**Meeting Summary, Southwest Florida Water Management District,
Proposed Minimum Flow for the Rainbow River System Public
Workshop, Dunnellon City Hall, Dunnellon, Florida.**

Southwest Florida Water Management District Proposed Minimum Flow for the Rainbow River System Public Workshop

Dunnellon City Hall
Dunnellon, Florida
February 23, 2017

Proposed Rainbow River System Proposed MFL
(95% of historical average)

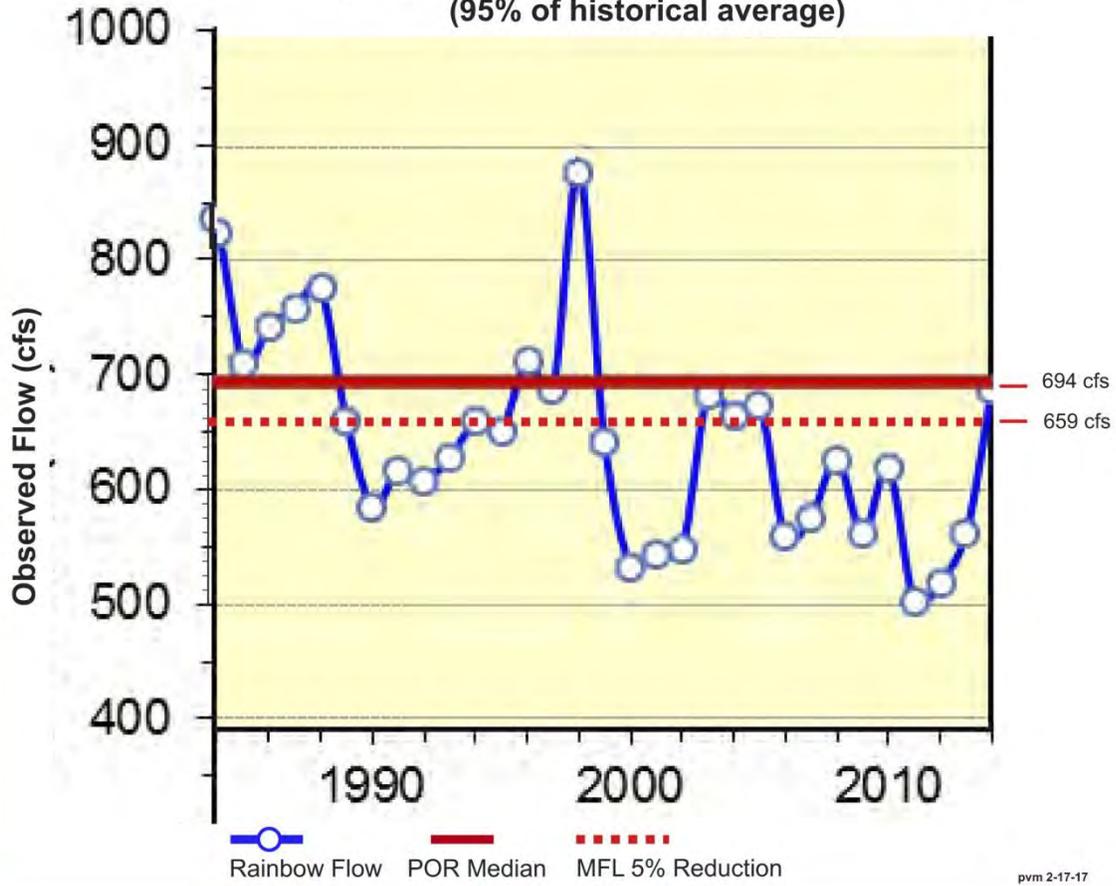
* Draft - Recommended Minimum Flow for the Rainbow River System page 22, and Figure 2-8

Spring Discharge @ US 484	Grade	Average (2012-2016)	A: > 776 cfs B: 713 - 775 cfs C: 660 - 712 cfs D: 610 - 659 cfs F: < 609 cfs
	F	598 cfs

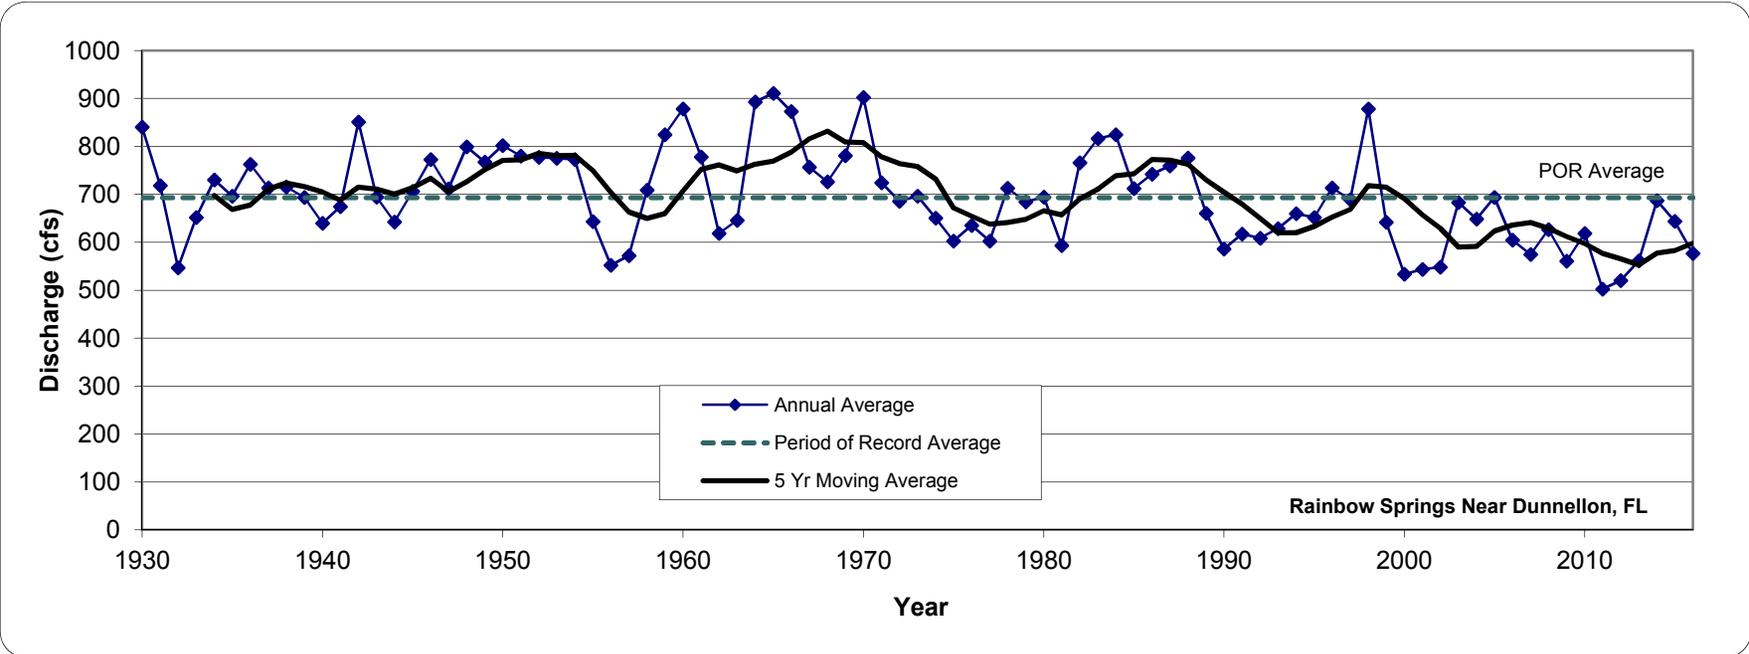
RAINBOW SPRINGS AND RIVER

Water Clarity @ Spring Run	Grade	Average (2015-2016)	A: > 70 %
	B	64% Light Transmittance @ 1 meter	B: 60 - 69 % C: 50 - 59 % D: 40 - 49 % F: < 40 %

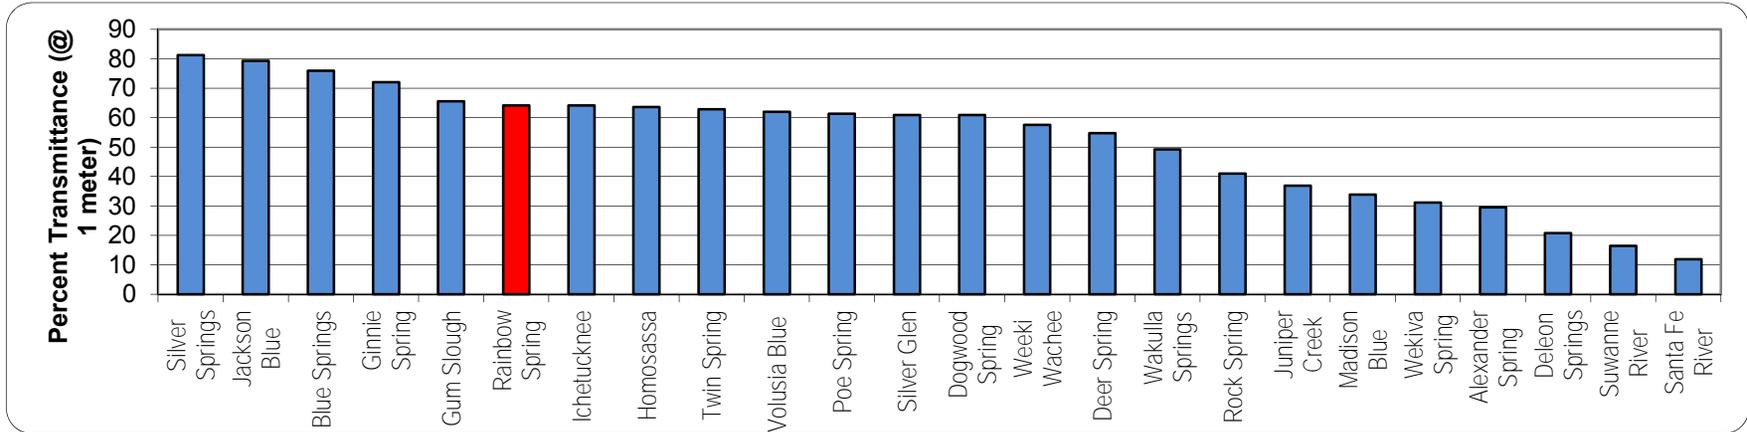
RAINBOW SPRINGS AND RIVER

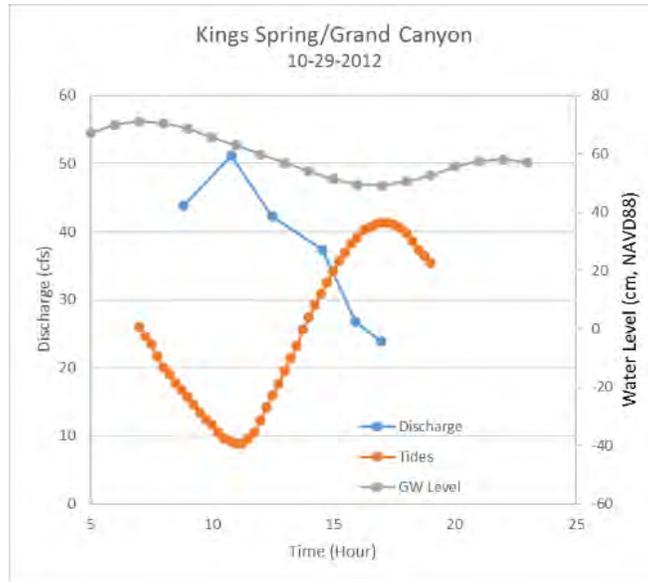
The point I was making regarding Figure 2-4 is that spring flow for the 8 springs in Group 2 shows changes from 0 to 250-270 cfs in the 6 hour tidal cycle on a number of days. (Note:On some days negative flows are shown; a point mentioned in the text of the original paper.) There is not a shred of evidence supporting this large change. Dr. Chen claimed there is no data on discharges from individual springs over a tidal cycle; however he fails to see the discharge measurements for the individual springs in the 2009 study period do have MSL data, which tends to show consistent discharge not major changes. While the 2012 discharge measurements do not show the corresponding stage data, the time of measurement can be cross-referenced to USGS Gage Mouth of Kings Bay for individual springs. Additionally, an effort was made in 2012 VHB work specifically collect discharge from three springs over a tidal cycle, shown in Table 2 of the Technical Memorandum. I have written in the corresponding

USGS Gage Height for the time of the measurement. Spring 32 does not support changes of the magnitude calculated and shown in Figure 2-4. Note: the model treats all springs close to G2 the same, so Spring 32 is modeled the same as G2, CORRECT?

Staff Response: Yes, Spring 32 is modeled in the same way as that for G2 springs, with the same C_1 and C_2 parameters. However, the ΔG (sometimes also called G_0) parameter is a linear function of the distance to the ROMP TR21-3 well.

Proposed Rainbow River System Proposed MFL
(95% of historical average)

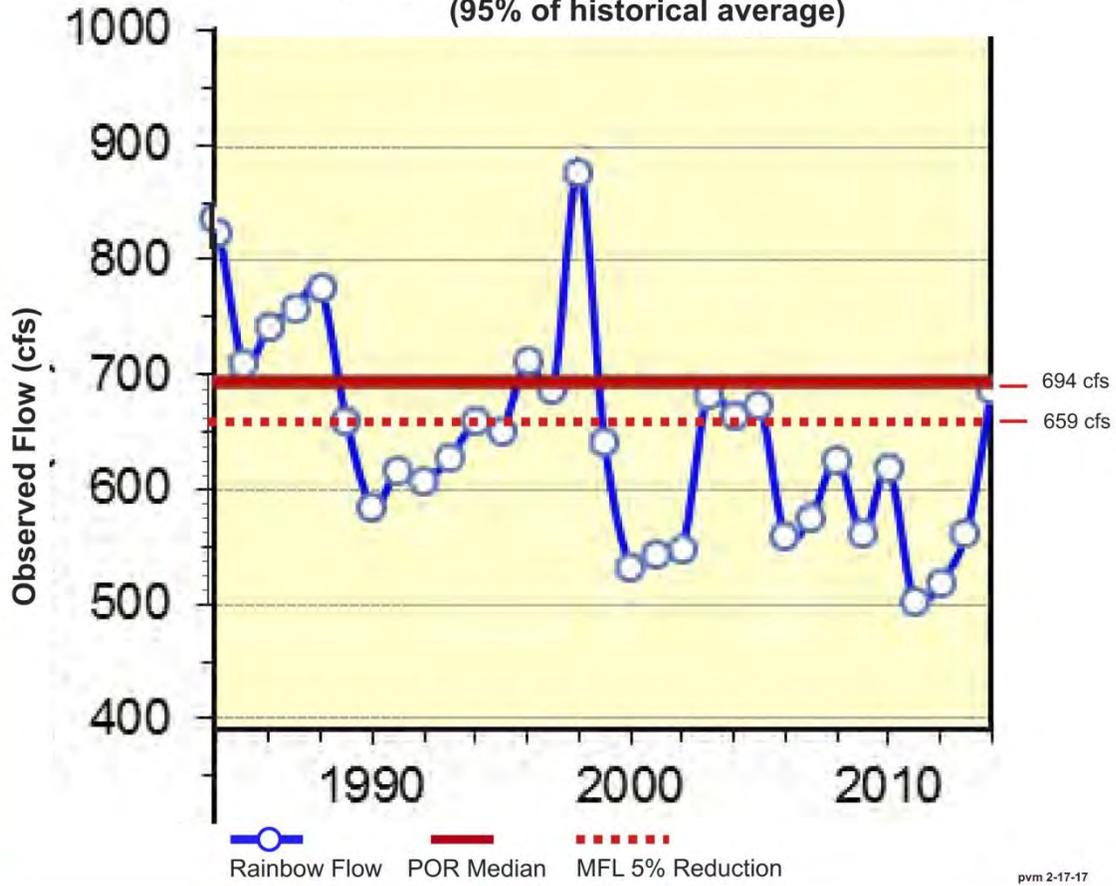
* Draft - Recommended Minimum Flow for the Rainbow River System page 22, and Figure 2-8
 Principle author Kym Rouse Holzwart
